MANUAL IDENTIFICATION

Model Number: 8690B
Date Printed: May 1972
Part Number: 08690-90018

This supplement contains important information for correcting manual errors and for adapting the manual to instruments containing improvements made after the printing of the manual.

P/O Figure 7-3. Frequency Control Section Reciprocal Amplifier

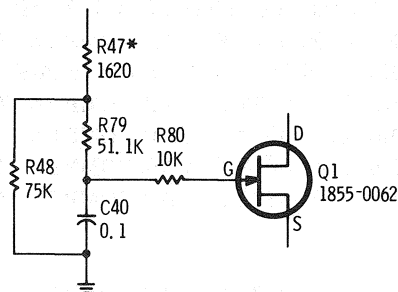
Change the circuitry of A3Q1 as shown in the attached drawing:

Component Identification, Assembly A9

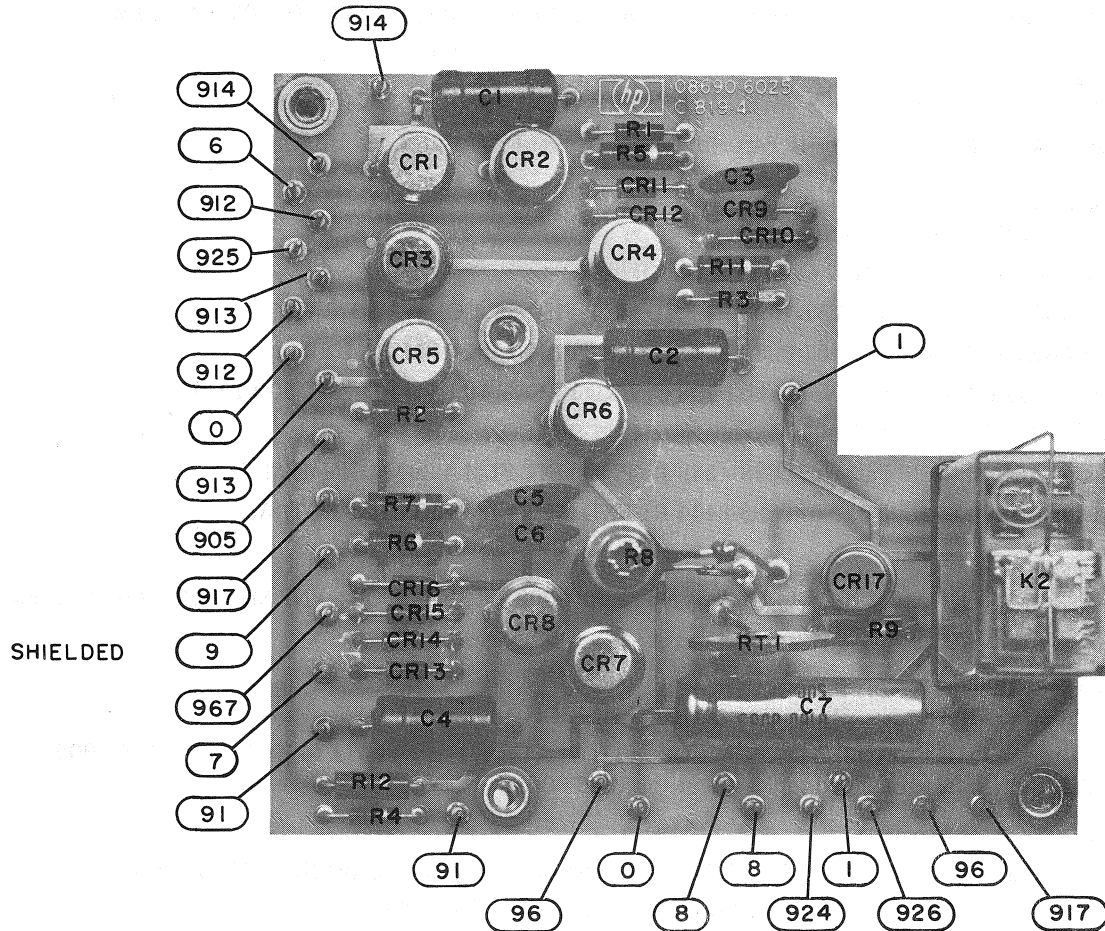
Substitute the attached A9 Component Identification board for that shown in the 8690B Manual.

Figure 1. Component Identification, Assembly A8 (Part of Change 1)

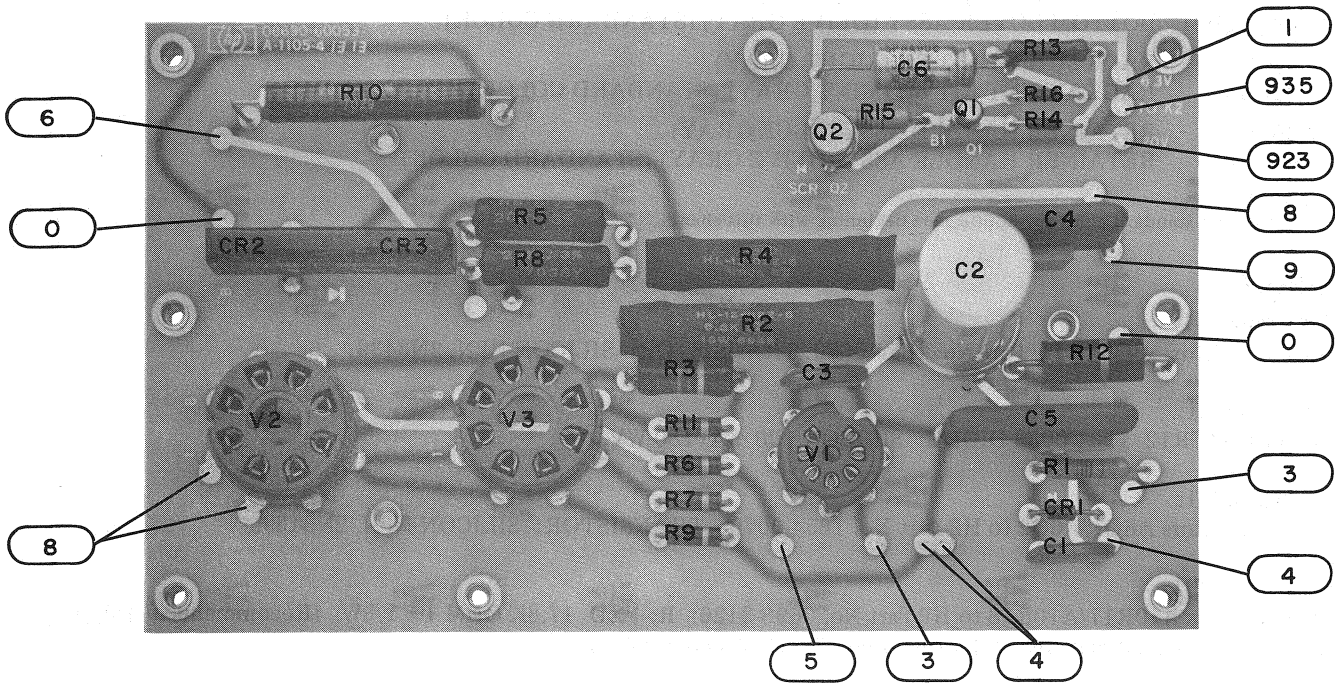
Substitute the attached A8 Assy, Component Identification board photo (Figure 1) for the photo shown in the 8690B Manual.

Figure 2. Component Identification, Assembly A14 (Part of Change 2)

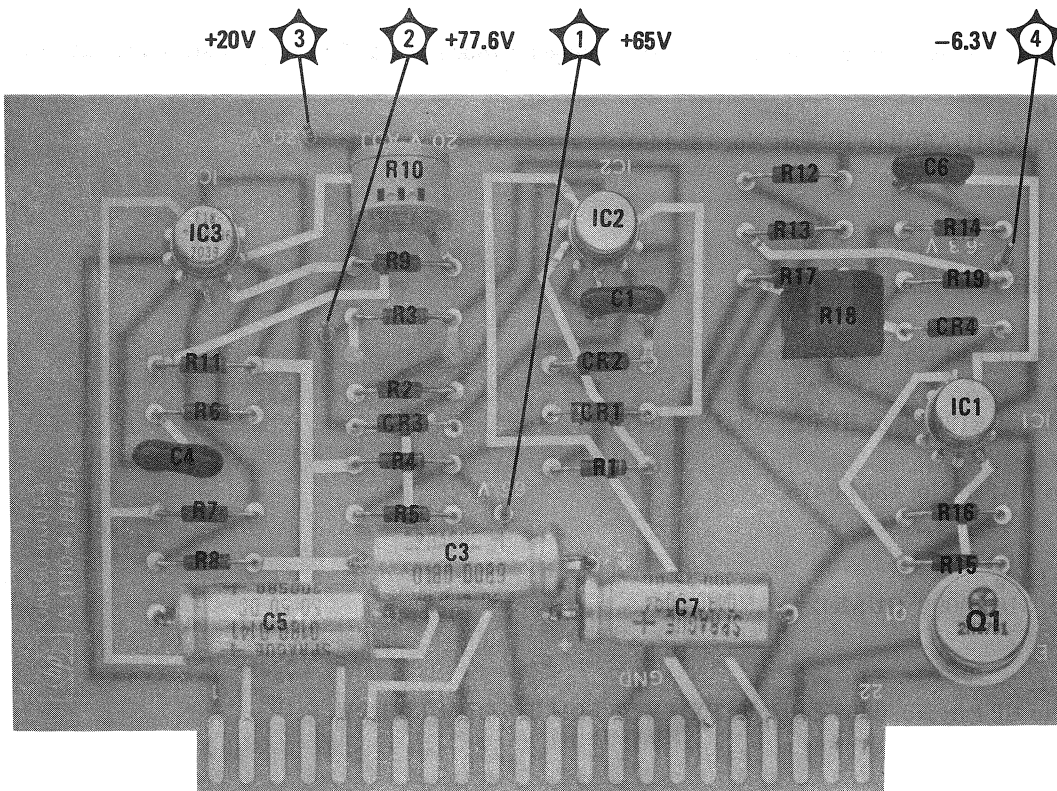
Substitute the attached A14 Assy board photo and schematic (Figures 2 and 3) for those shown in the 8690B Manual.

Figure 4. Component Identification, Assembly A4 (Part of Change 5)

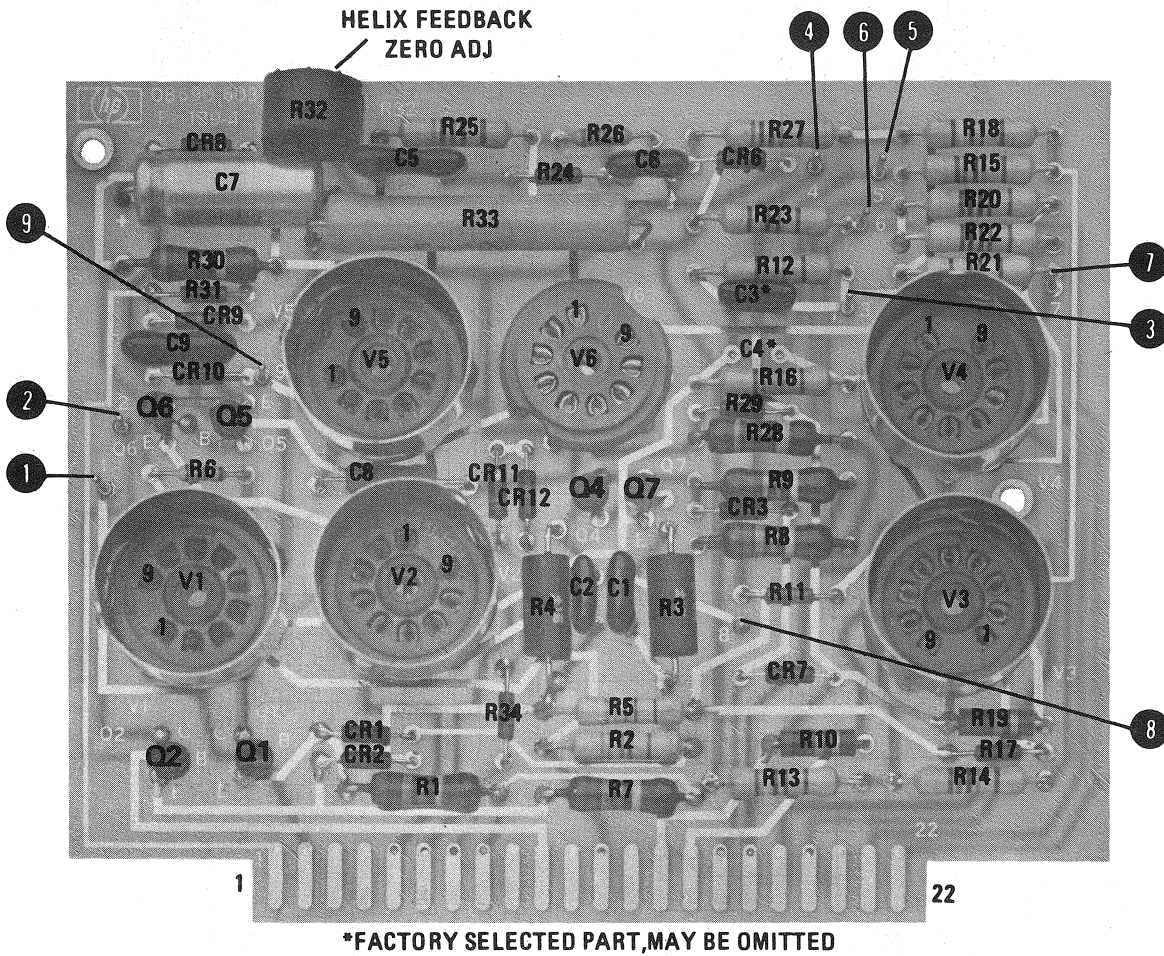
Add diode A4CR12 in series with zener diode A4CR11. Connect cathode of A4CR12 to ground, and anode to A4CR11.

Figure 5. Component Identification, Assembly A3 (Part of Change 1)

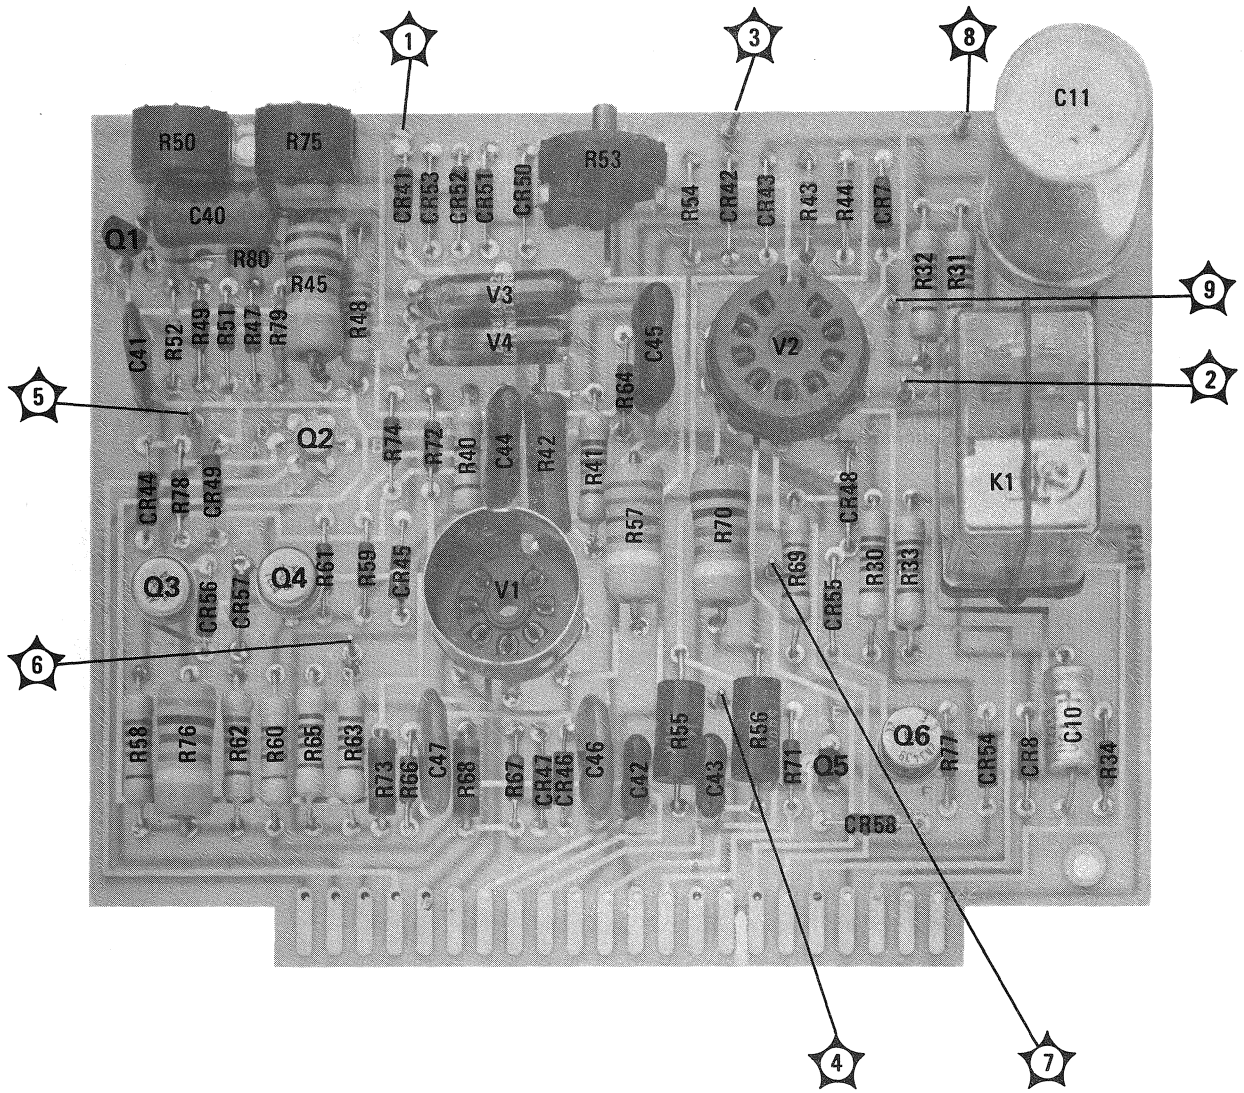
Substitute the attached Component Identification Assembly A3 board photo (Figure 5) for the photo shown in the manual.

Figure 6. Partial Schematic Diagram of the Power Supply Section Showing Thermal Switch S15
(Part of Change 10)

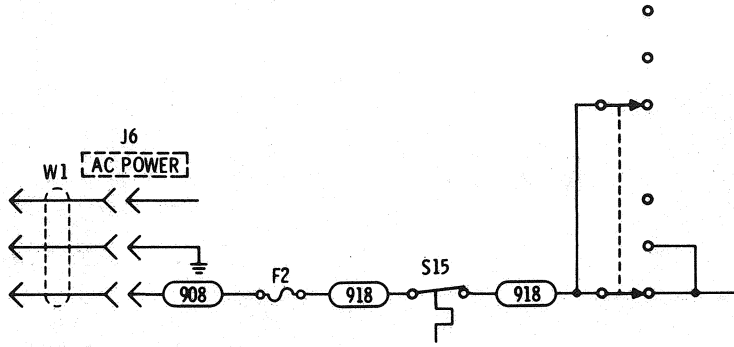
Add thermal switch S15 to schematic diagram of Power Supply Section as shown in Figure 6.
